**ADDENDUM NO. 06**  
February 09, 2010

Project: **Package C – 2009: Holbrook Elementary School Renovations**  
Cypress-Fairbanks Independent School District

Bay Project No.: 0840 (10-01-2069R-FP)

ADDENDUM#  
 6-SKT-1  
 SHEET NO.:  
 C2.04

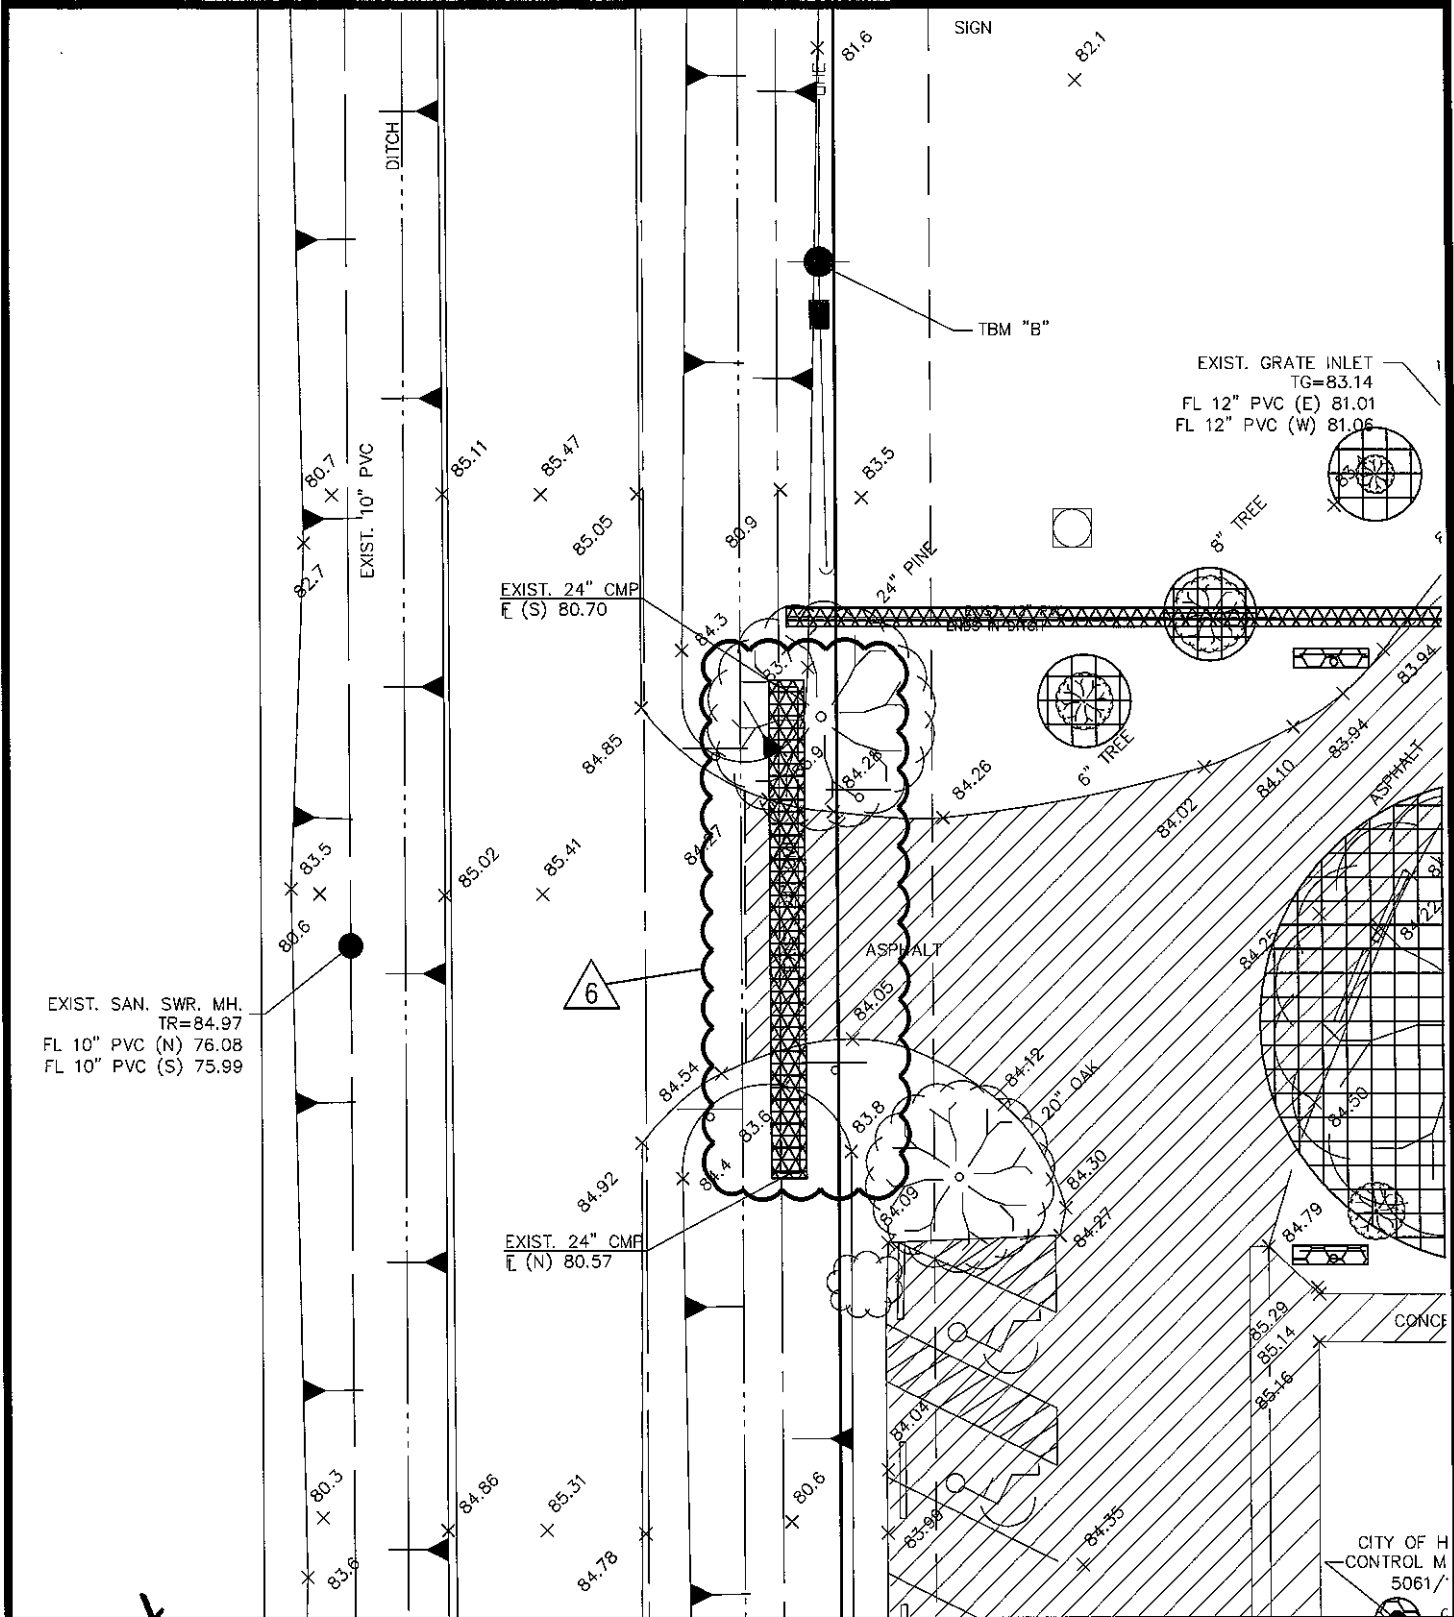
- 07. Sheet C2.04 - Demolition Plan
  - a. Added demolition of a portion on an existing culvert as indicated on attached sketch ADD-6-SKT-1.
  - b. Added demolition of existing culvert and revised pavement demolition at existing exit drive as indicated on attached sketch ADD-6-SKT-2.
  - c. Added demolition of existing culvert as indicated on attached sketch ADD-6-SKT-3.

ADDENDUM#  
 6-SKT-4

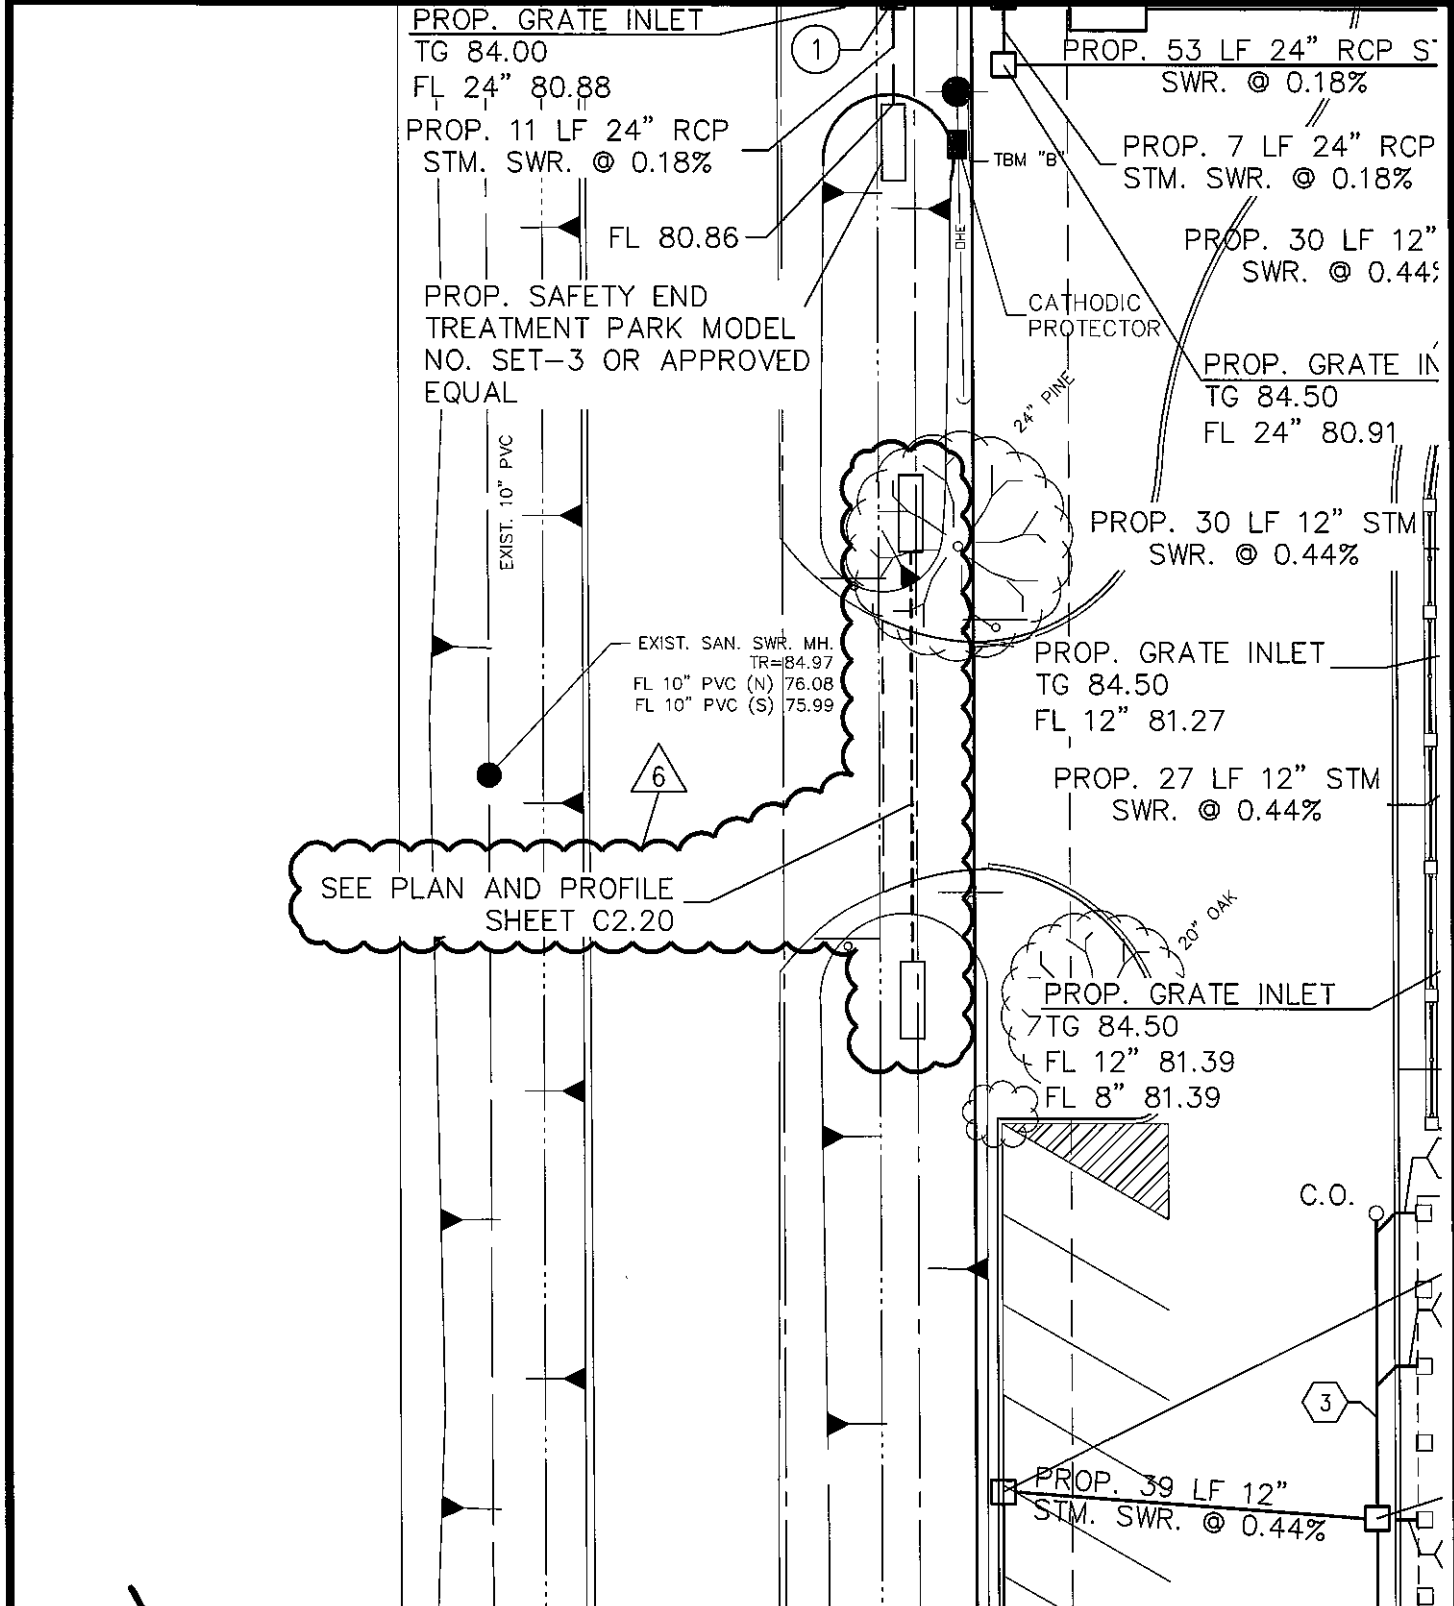
- 08. Sheet C2.06 and C2.06A – Storm Sewer Plan (Base Bid) and (Alternate)
  - a. Added reference note for replacement of existing culvert at north drive in Langfield right-of-way as indicated on attached sketch ADD-6-SKT-4.

ADDENDUM#  
 6-SKT-5

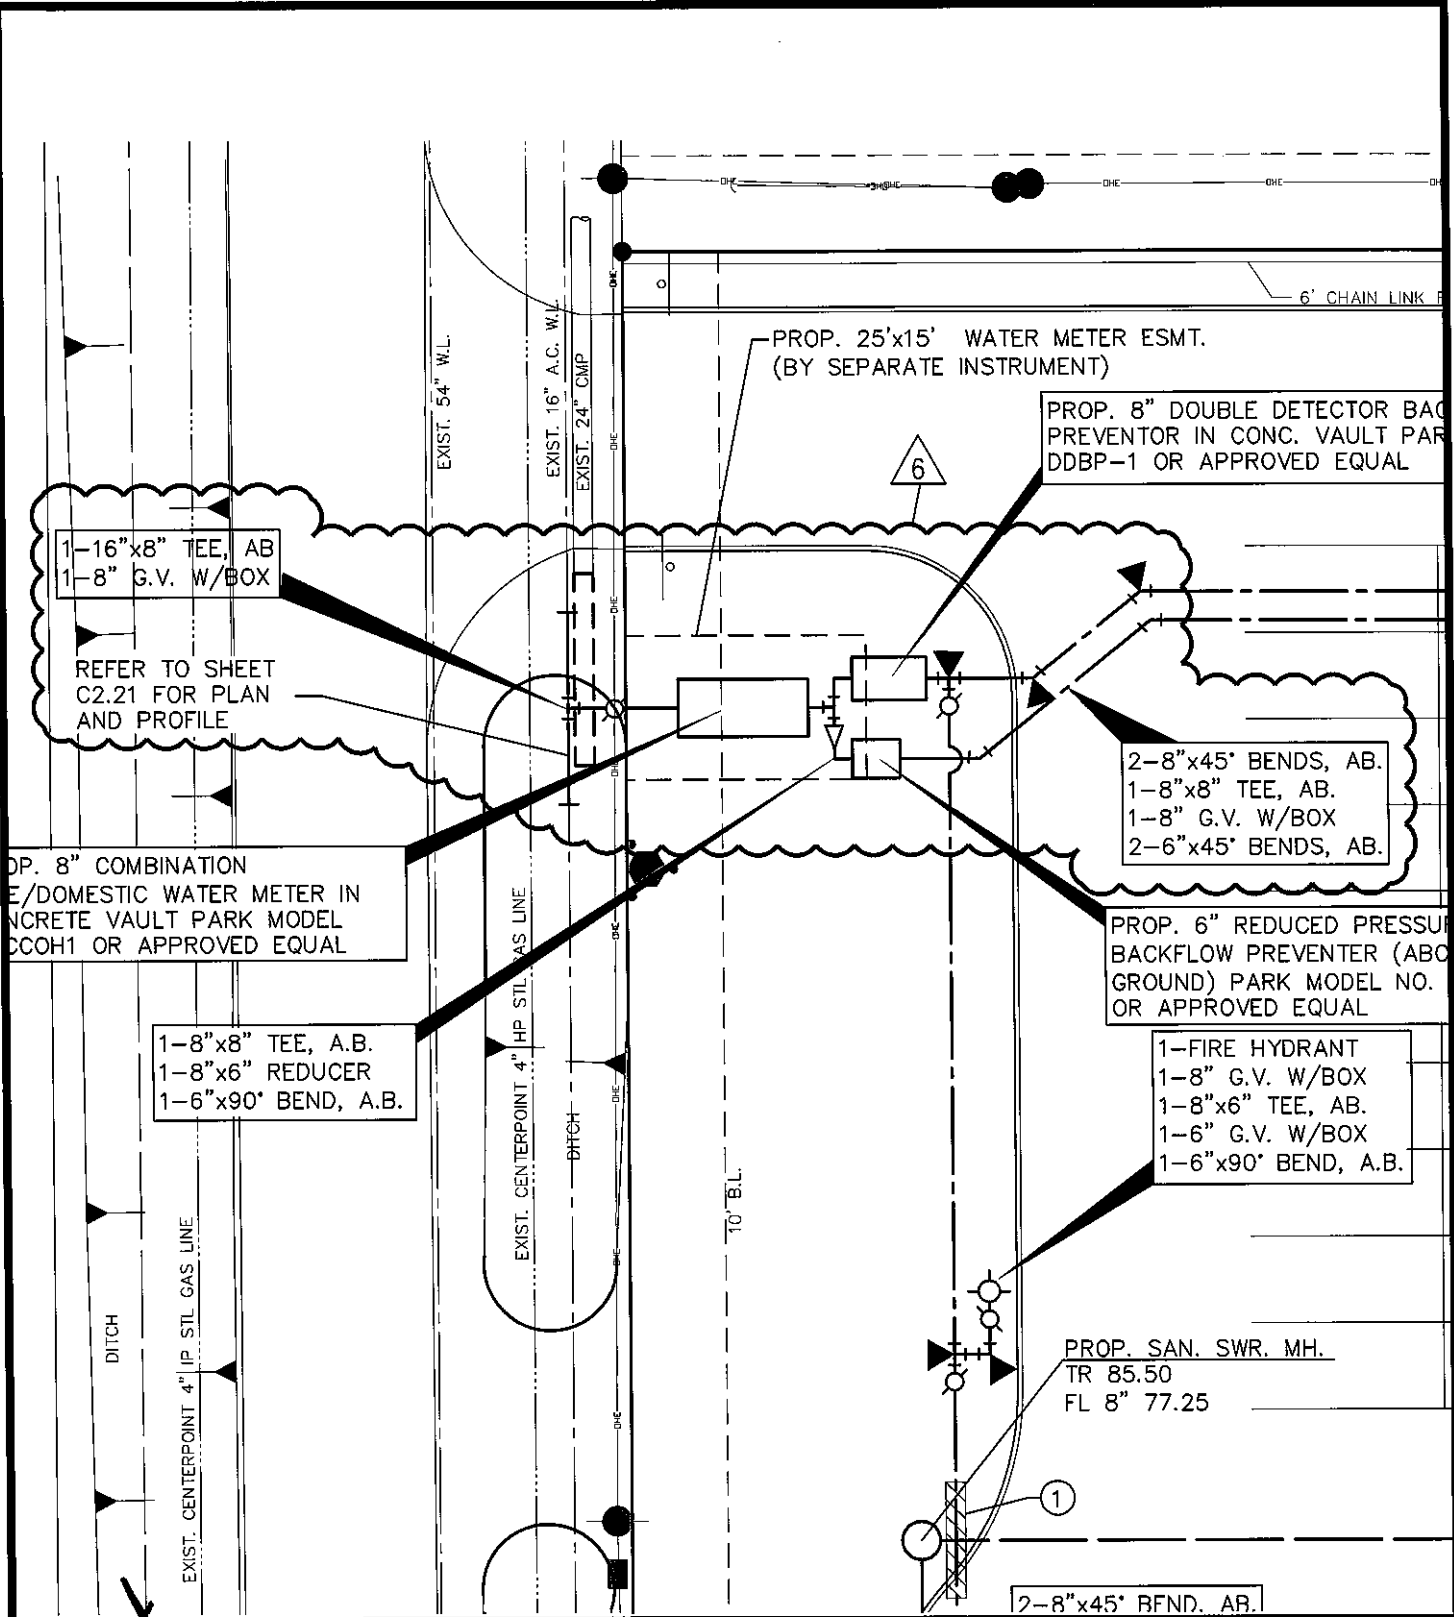
- b. Added reference note for replacement of existing culvert at existing exit drive in Langfield right-of-way as indicated on attached sketch ADD-6-SKT-5.

ADDENDUM#  
 6-SKT-6

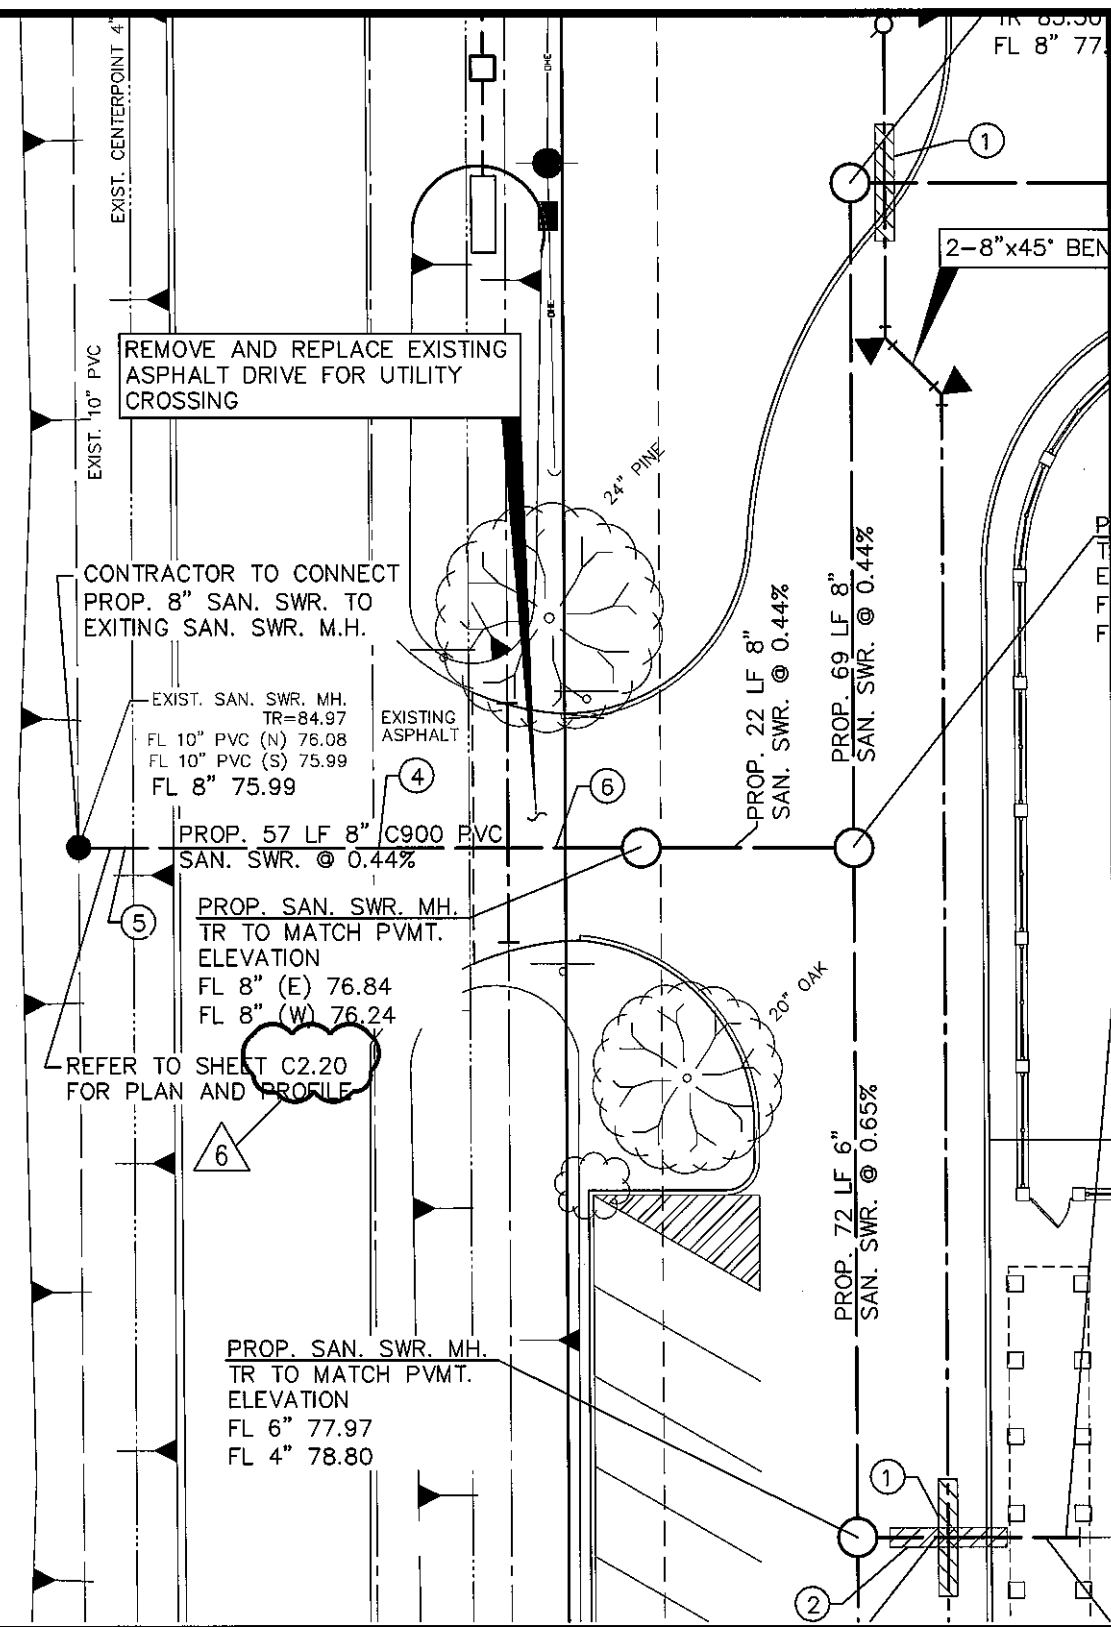
- 09. Sheet C2.10 – Water and Sanitary Sewer Plan
  - a. Revised location of proposed water meter and backflow assemblies to accommodate water line connection to existing 16" waterline in right-of-way as indicated on attached sketch ADD-6-SKT-6. Also added reference note for the proposed water line plan and profile work in Langfield right-of-way.
